Additional assembly site for TO-220 products - Revised D2Pak removed

PCN Reference: 220-PCN90-Public

Additional assembly site

TO220-AB POD COMPARISON

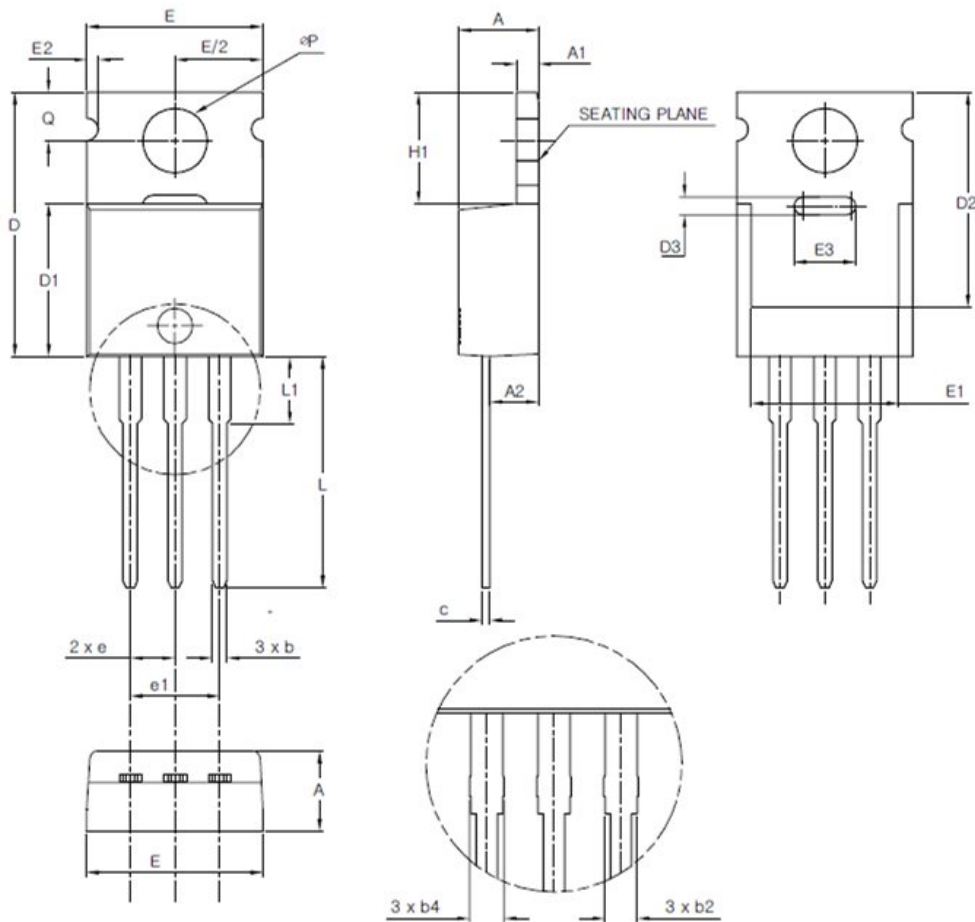
Additional assembly site for TO-220 products - **Revised D2Pak removed** Super Power Semiconductors (Korea) will be the alternate assembly site for the part numbers identified in the following page. As a result of this change, the package will change as follows

PACKAGE	ITEM	EXISTING	TARGET
TO-220	Assembly site	International Rectifier Mexico	Super Power Semiconductors (SP Korea)
	Mold compound	43-9807	44-1197
	Wire	Ni-doped Aluminum	Aluminum
	Die attach solder	Sn/Ag/Sb	Pb/Sn/Ag
	Leadframe	Selective Ni	Bare Copper
	Lead plating	Sn/0.7Cu Solder Dip	100 Matte Sn

Reference	IR POD		SP POD		JEDEC POD	
	Min	Max	Min	Max	Min	Max
A	3.56	4.83	3.56	4.83	3.56	4.83
A1	0.51	1.40	0.51	1.40	0.51	1.40
A2	2.03	2.92	2.03	2.92	2.03	2.92
b	0.38	1.01	0.38	1.01	0.38	1.01
b2	1.14	1.78	1.14	1.78	1.14	1.78
c	0.36	0.61	0.36	0.61	0.36	0.61
D	14.22	16.51	14.22	16.51	14.22	16.51
D1	8.38	9.02	8.38	9.02	8.38	9.02
D2	11.68	12.88	11.68	12.88	12.19	12.88
E	9.65	10.67	9.65	10.67	9.65	10.67
E1	6.86	8.89	6.86	8.89	6.86	8.89
e	100 BSC		100 BSC		100 BSC	
H1	5.84	6.86	5.84	6.86	5.84	6.86
L	12.70	14.73	12.70	14.73	12.70	14.73
L1	3.56	4.06	3.56	4.06	3.56	4.06
ØP	3.54	4.08	3.54	4.08	3.54	4.08
Q	2.54	3.42	2.54	3.42	2.54	3.42
